**Aurizon Network Pty Ltd (Aurizon Network) – FY2018 Capital Expenditure Submission**

2019  
Response to Draft Decision  
FY18 Capital Expenditure  
Claim

### IV.00154 - Autotransformer Renewal Project

5055.003 C01\_1...

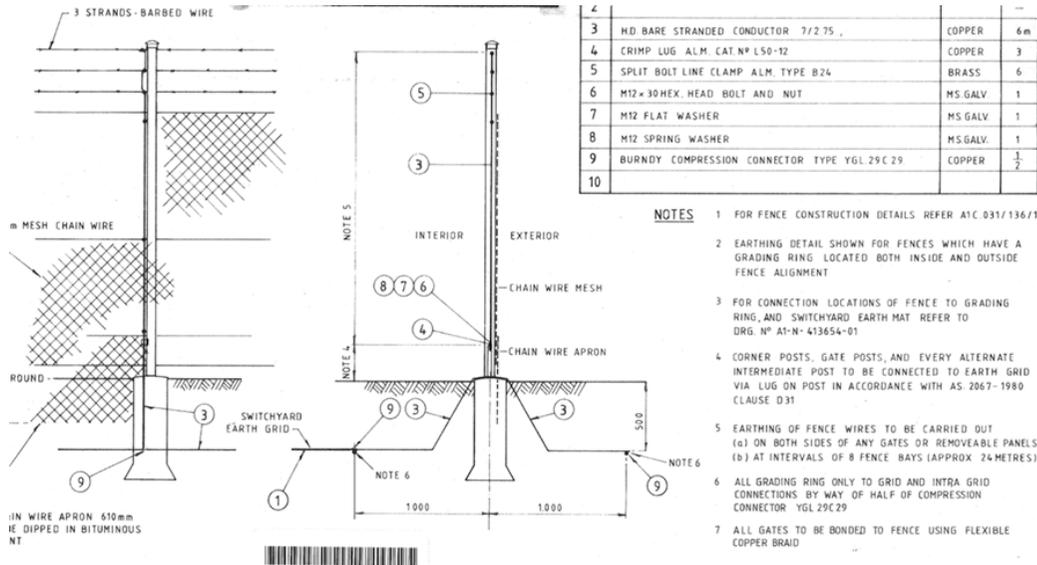
- From the photos provided of Balook AT1 and Epala AT1 (attached) it does not appear that bunds have been fitted to these ATs. Can Aurizon Network please confirm that oil containment bunds have been retrofitted at Balook AT1 and Epala AT1, and provide evidence of this (i.e. photos showing extent of the bund)?

RPEO signed off Civil Drawing for IV154:

AT Bund photos in transmittal 29.03.2019 - <https://aurizonholdings.sharepoint.com/f:/r/sites/fy18capexclaimv2/Shared%20Documents/10%20Transmittal%2029.03.2019?csf=1&e=3zIPV>

# Renewed AT Site – Proposed Bund Wall Reinforcement Earthing

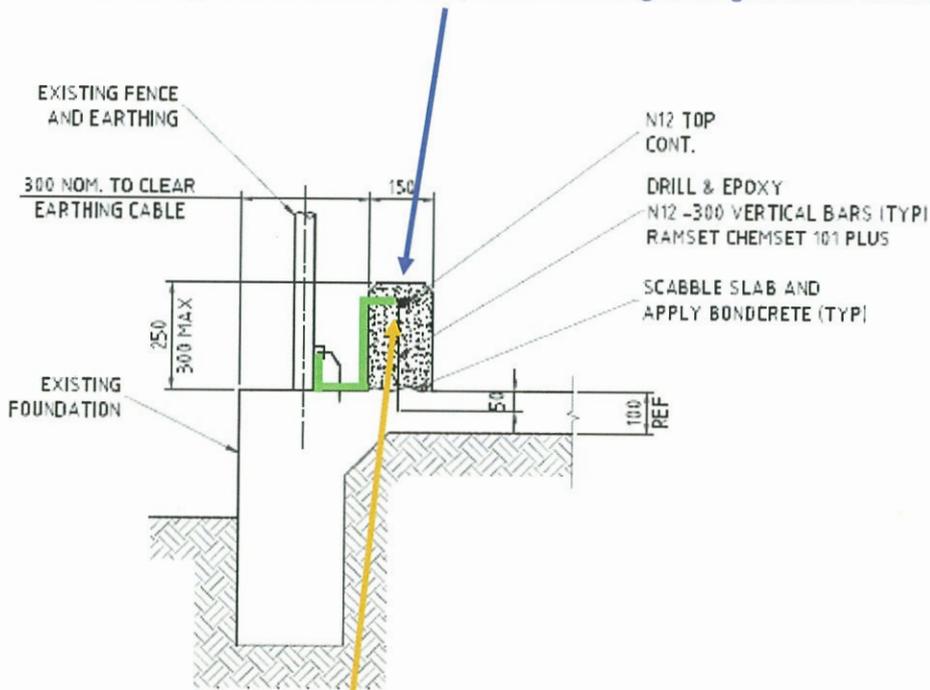
*"...Aurizon Network did not provide documentation, beyond verbal confirmation and photographs necessary for AECOM to verify correct connection of oil containment bunds to the earth grid, in accordance with safety standards."*<sup>1</sup>

Aurizon Network concludes that the earthing will not impact the extremely low risk associated with these sites, however it will address this item. Aurizon Network intends to complete the connection of the steel reinforcing within the new oil containment bunds to the existing earth grid (estimated at \$10k per site) in a future year and intend to include these associate costs within a future Capex Claim. Aurizon Network will include the earthing for all future renewal sites into the forward-looking autotransformer renewal program. Refer to Appendix C for Aurizon Networks proposed bund wall earth connection arrangement.

Install a suitable Earth Conductor between Bund Wall reinforcing and site Earth Grid.

Cut/chase top of bund wall and expose horizontal N12 reinforcing bar. Clean bar and weld earthing bond to reinforcing bar. Lug earth conductor end and bolt to flat earthing strap. Flat earthing strap to be Hilti fitted for low, safe profile on outside face of bund wall and across existing slab. Bond earth strap to the existing earth grid at the enclosure fence.
